Operator N. Dale Nichols
 Well Avulanche Journal State #4
 Unit 16 Section 4 Township 8 Range 27
 API # 30-005-10471

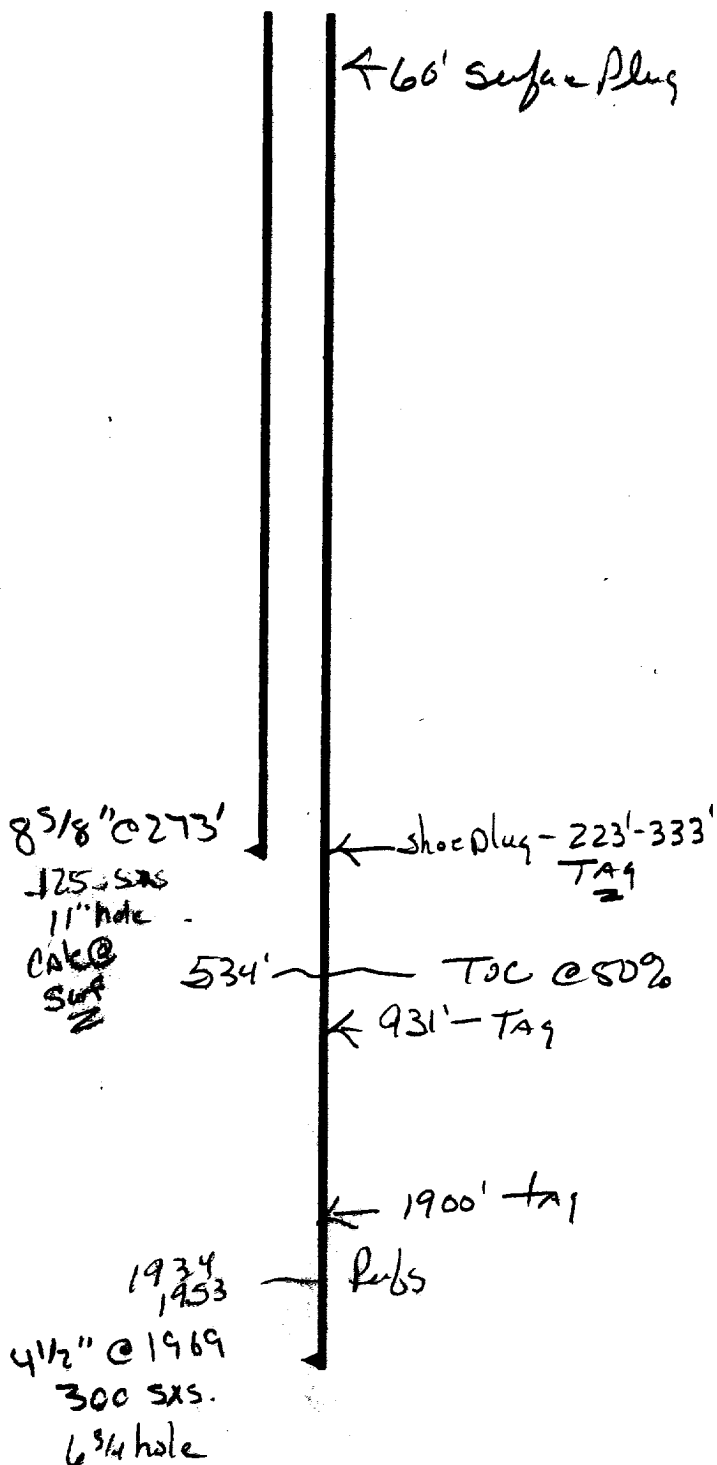
- * Contact OCD 24 hrs. prior to any work done.
- * Salt gel mud consisting of 10# brine with 25# of gel per barrel must be placed between each plug.
- * Install dry hole marker as per Rule 202.B.2
- * Plugs are to be set from point indicated up.
- * Plugs must not be less than 100' or 25 Sacks of cement, whichever is greater, unless specifically indicated.
- * Shoe and stub plugs will be 50' above and below shoe or stub and tagged.
- * Surface plug will be from 0' - 60'
- * Where plugs are required, cement must be placed inside and outside of all casing string(s) in the correct footage or sacks required, if no cement exists.
- * Plugs to be tagged will be indicated.
